# SERVICE BULLETIN

Subject: **TS30 Belt Production Problem**

Bulletin Nu: **TS30-FM-2302**

**Description of the modification:** TS30 Belt  
Production V-CUT Problem

#### Correct Production Dates

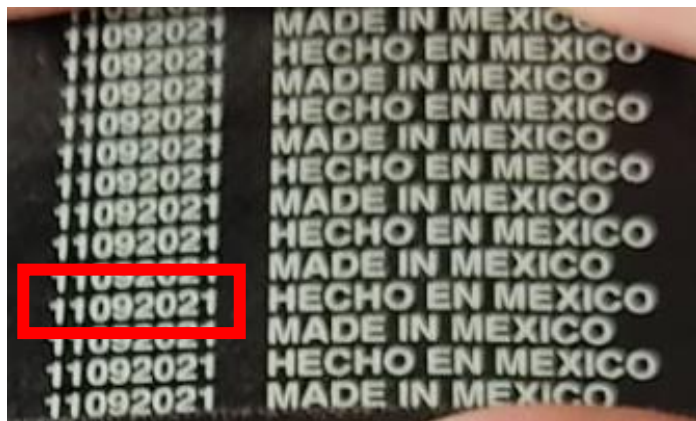
\*Belts before the year 2022 and after the 9th month of 2022 are correct.

Before 01.01.2022

After 01.09.2022

#### Incorrect Production Dates

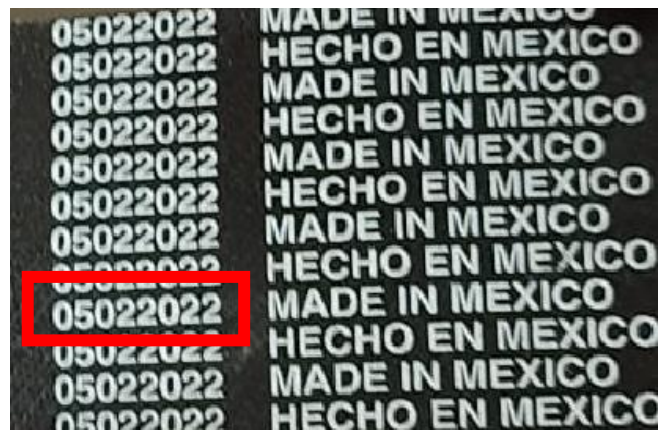
\* Belts after 2022 and before the 9th month of 2022 are incorrect.

01.01.2022

01.09.2022

- \*If the belts are correct after the checks, don't apply the bulletin.**
- \* If the belts aren't correct, you must apply the bulletin.**
